PLANNING CLEARANCE
(Single Family Residential and Accessory Structures)
Community Development Department

Building Address 2077 RAINDANCE CT.
Parcel No. 2947-151-53-004
Subdivision INDEPENDENCE RANCH
Filing 11 Block 1 Lot 4

Re: Slope Concerns for Pool Construction
Corsi Residence, 2077 Raindance Court, Grand Junction, CO

Re: Building/Slope Setback, 2077 Raindance Ct., Grand Junction, CO

SLOPE SETBACK DIAGRAM

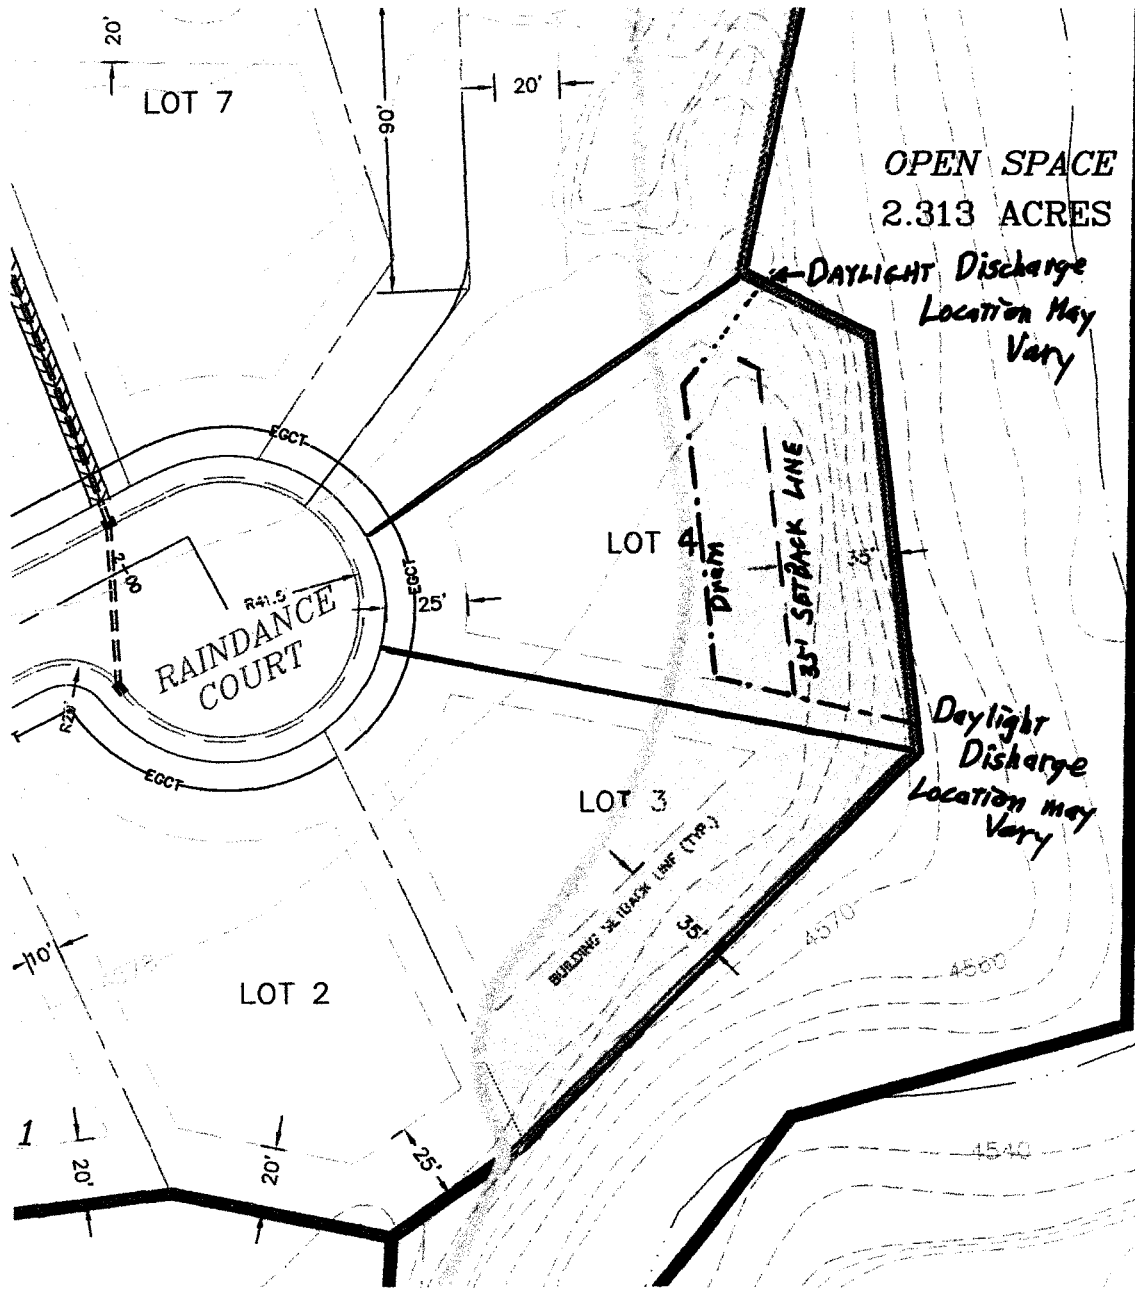
These sections show the building setbacks, without remedial drainage measures. The Thompson Langford drawing indicates a 35' Building Setback Line (Typ.), which requires the construction of a subsurface drain. A drain is to be installed, meeting the following requirements.

- The subsurface drain is to be placed at least 25 feet within (northwest of) the 35' Building Setback Line.
- The drain is to extend down to and at least 6 inches into the Mancos Shale, beneath the structure.

- The drain is to grade to a 'daylight' discharge, both south of the structure and northeast of the structure (2 outlets).
- The drain 'channel' shall be 'sealed' with a plastic or rubber membrane to minimize drain water from entering the Mancos Shale.

- The drain is to collect/intercept subsurface water which is moving in from the west and northwest of the site. A Free Water Surface must not develop in the 'Back Yard' area, east of the structure.

- Onsite roof downspouts must **not** discharge into this drain, but may utilize separate sealed piping which is laid within the same trench.
- The attached diagram '*Underground Moisture Barrier and Drain*' demonstrates the above requirements and our recommendations.

Figure II-6

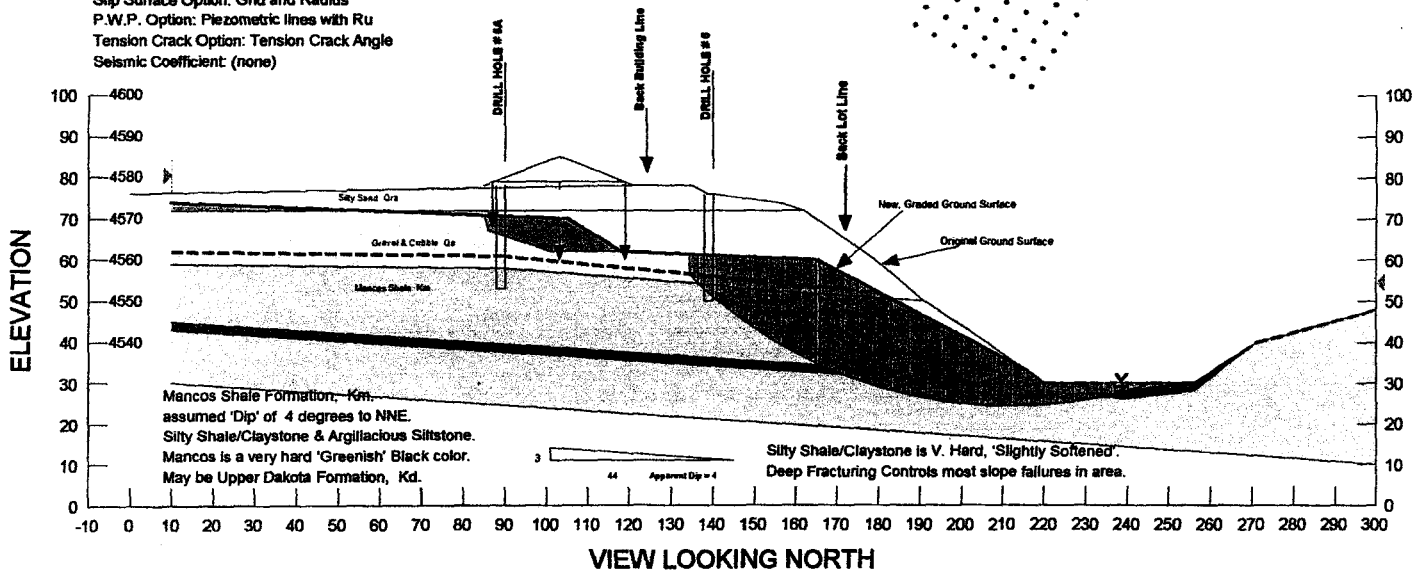
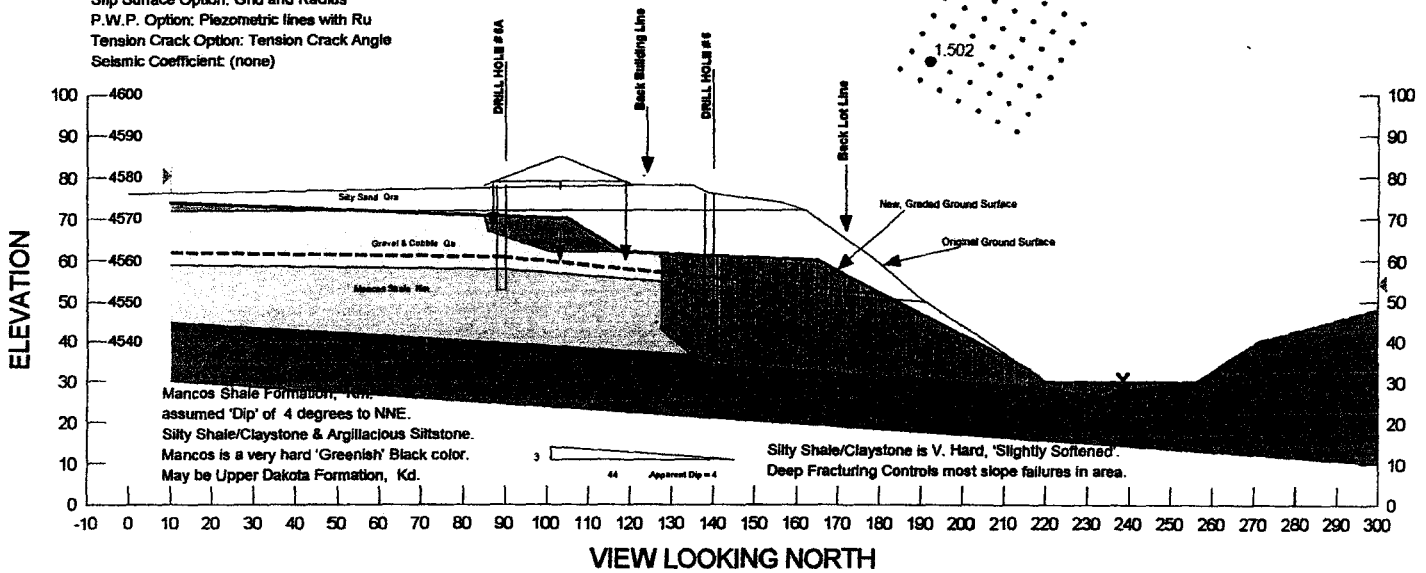
The pool area corresponds with the previous slope study for Section S-6 along the north side of the now present residence. The original figures presented in our report of Building Slope Setback for this site are still appropriate. The constructed slope is slightly different from our assumptions in that approximately 1 to 2 feet of additional material has been pushed out over the slope edge during the final construction and grading of this residence. This extra material was modeled utilizing the GEO Studio 2004, V. 6.21, Slope/W Module. The additional material at the top edge of the slope has virtually no effect on the overall slope stability but represents a material which will undergo long-term sloughing type failure.

The existing pool excavation is within the bounded area of a computed safety factor of 1.82 at the extreme west end, closest to the residence, and 1.42 at the extreme east/northeast end, closest to the slope edge. For structures such as a pool and associated concrete slabs, a safety factor of 1.3 or greater is normally considered appropriate. The pool structure should not adversely affect the slope stability on this lot, and the computed slope stability safety factors are such that movement beneath the pool structure is not anticipated. Due to the lower computed safety factors close to the bank edge, we recommend that slab and apron construction, which adjoins the pool, be terminated at 10 feet from the original bank edge approximately 11 to 12 feet from the existing, slightly modified bank edge. This area may undergo minor sloughing over the years and will probably undergo minor distortion in the area up to 10 feet away from the original bank edge. This distortion may not incorporate a full slope failure but would be similar to what is referred to as soil creep by engineering geologists.

To minimize long-term distortion of the bank edge and sloughing of the thin soils on the actual slope edge, the original recommendations contained in our Building Slope Setback Report of August 18, 2005 are restated to account for the pool construction and increased concrete slabs on grade in this area.

- The subsurface drain around the structure, which has been exposed at the time of our observations, needs to be reconnected, and the actual discharge needs to be confirmed as to location and operability.

- Since this drain is not set in the Mancos Shale Formation as required in our original letter report, the effectiveness of this drain is greatly diminished.

- The drain daylight discharge to the northeast of the structure must be confirmed. The drain channel has not been properly constructed with a plastic or rubber membrane underneath the drain so that water collected in the drain is allowed to enter the underlying soils along the length of the drain.

- It must be emphasized that a free water surface must not develop within this backyard area, particularly within the pool area. Proper removal of downspout discharges, limiting the landscape irrigation, and proper maintenance of the plumbing associated with this pool structure are very important.

- The onsite roof downspouts must be continued past the drain and pool area, to discharge well away from the structure. The discharges at this end of the structure are to continue past the pool area.
